UNITED STATES PATENT AND TRADEMARK OFFICE

Office Action Summary	Application No. 10/550,802	Applicant(s) SUZUKI ET AL.	
	Examiner NAHID AMIRI	Art Unit 3679

DETAILED ACTION

Fig. 2A

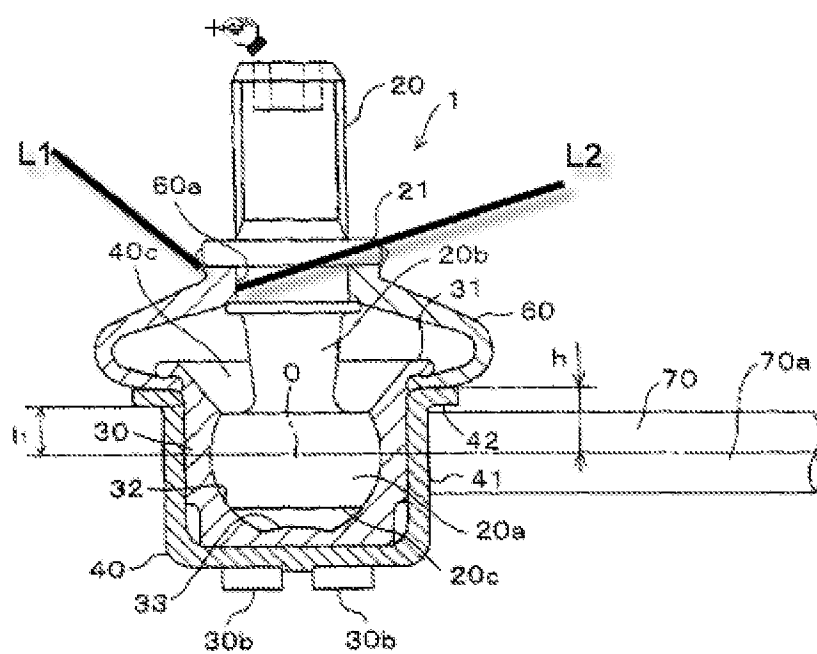
With respect to claim 1, Kuroda discloses a ball joint (Fig. 2A) comprising a housing (40) with an opening portion; a ball head portion (20a) rotatably housed in said housing (40); a ball stud (20) comprising a stud portion (20b) provided in a protruding manner from said ball head portion (20a), and protruding from said opening portion; and a brim portion (21) provided in a protruding manner on an outside surface of said stud portion (20b); and an approximately pipe-formed dust cover (60) inserted through said stud portion (20b), provided across an outside surface of said housing (40) and an outside surface of said stud portion (20b) so as to block said opening portion, said dust cover (60) comprising a first lip portion (L1) closely fitted in a manner urged toward a ball head portion-side end face of said brim portion (21); and a second lip portion (L2) which is closely fitted in a manner urged toward an outside surface of said brim portion (21). Kuroda fails to disclose that the dust cover is an elastic material. Fukukawa et al. teaches a ball joint (Fig. 1) having an elastic dust cover (5). It would have been obvious to one of

With respect to claims 2, 3, and 5, Kuroda discloses (Fig. 2A) that the first lip portion (L1) is urged toward a ball head portion-side end face of said brim portion (21), and closely fitted to a part of said end face; and wherein second lip portion (L2) is urged toward an outside surface of the brim portion (21), and closely fitted to a part of said outside surface.

FIG. 1

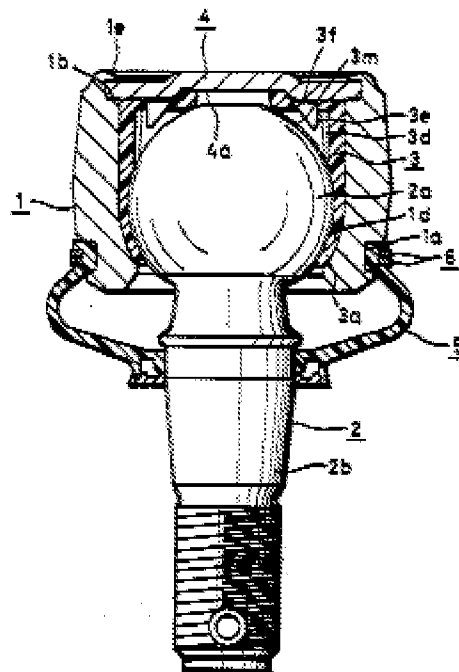
ordinary skill in the art at the time of invention was made to form the dust cover of Kuroda from elastic material as taught by Fukukawa et al. in order to provide a rust proof dust cover.

With respect to claim 9, Kuroda fails to disclose that the opening portion is located on one end of the housing, and the opposite end of the housing is closed by a plug caulked to the housing (3). Fukukawa et al. disclose a ball joint (Fig. 1) having an opening portion is located on one end of the housing (3), and the opposite end of the housing (3) is closed by a plug (4) caulked to the housing (3). It would have been obvious to one of ordinary skill in the art at the time of invention was made to provide the housing of Kuroda with a plug as taught by Fukukawa et al. in order to seal the top portion of the housing.

FIG. 7

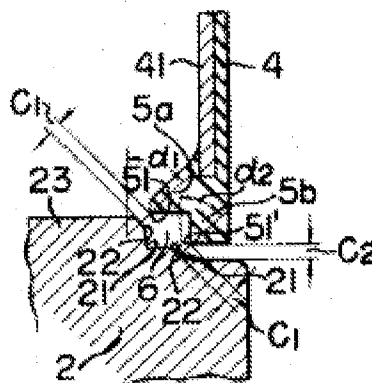
With respect to claims 4 and 6-8, Kuroda fails to disclose that the dust cover is provided with a pocket portion, said second lip portion and said brim portion of said ball stud, retaining a lubricant member inside. Takasashi teaches (Fig. 7) a seal lip (4) having a first and second lip portions (5a, 5b) is provided with a grease pocket portion (6) to retains a lubricant member (grease) inside. It would have been obvious to one of ordinary skill in the art at the time of invention was made to provide the dust cover of the Kuroda with a pocket portion to retains a lubricant member such as grease as taught by Takasashi in order to ease the movement between the seal lip and the brim member.
